Office Action Summary	Application No. 10/580,272	Applicant(s) NAKAMURA ET AL.	
	Examiner Shawn Riley	Art Unit 2838

DETAILED ACTION

FIG. 7

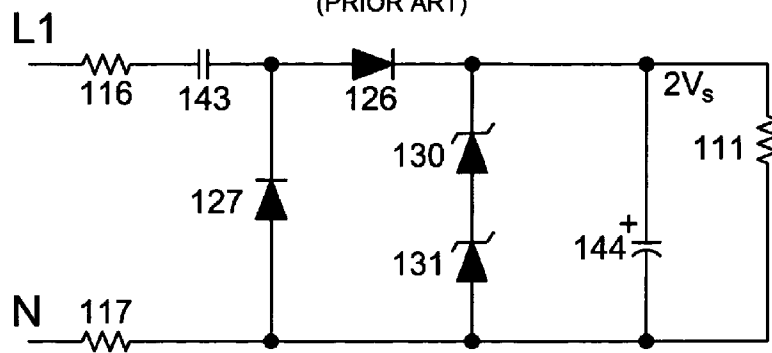
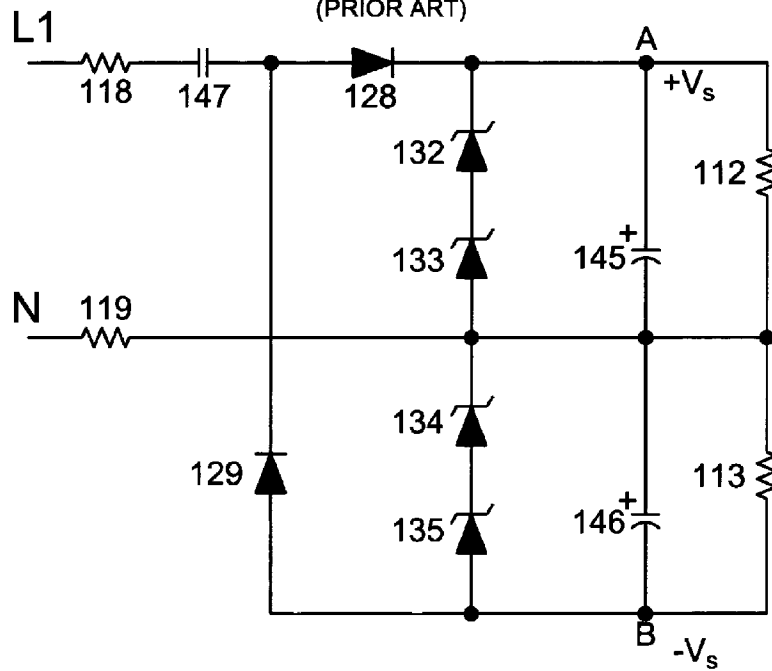
2. Claims 1-3, 5-7, 11, and 13 are rejected under 35 U.S.C. §102(e) as being fully anticipated by Momber (U.S. Patent 7,259,479). Momber shows,¹ (in, e.g., the(ir) figures 7-8 and corresponding disclosure)

A power converter for stepping down and converting AC voltage to DC voltage, said power converter comprising: first and second input connections (L1 7& N) for inputting output of said AC voltage; a first capacitor (143) and a second capacitor (144) interposed in series on a first electric connection line between said first input connection and said second input connection, connection in order from a side of said first input connection; a first diode (126) interposed between the first capacitor and said second capacitor on said first electric connection line so that its forward direction is toward said second input connection; a second diode (127) interposed on a second electric connection line so that its reverse direction is toward said second input connection, said second electric connection line connecting a point between said first capacitor and said first diode on said first electric connection line, and said second input connection; a first output connection (at, e.g., $2V_s$) for output of said DC voltage, which is connected between said first diode and said second capacitor on said first electric connection line; and a second output connection (connection node between 111 and 144) for output of said DC voltage, which is connected to said second input connection.

The power converter as set forth in claim 1, further comprising: a Zener diode (130/131) interposed between said first output connection and said second output connection so that its forward direction is toward said first output connection.

The power converter as set forth in claim 2, further comprising: a resistor (TH) interposed on said first electric connection line on a side closer to said first input connection than a position of connection with said second electric connection line (this line connection could be any second connection input/output apparently).

The power converter as set forth in claim 3, further comprising: a third capacitor (figure 8-146) connected between one end of said resistor (118) and said second input connection (N),

The power converter as set forth in claim 5, wherein said one end of said resistor (118) is the end on the side of said second input connection.

The power converter as set forth in claim 1, further comprising: a resistor (116) interposed on said first electric connection line on a side closer to said first input connection than a position of connection with said second electric connection line.
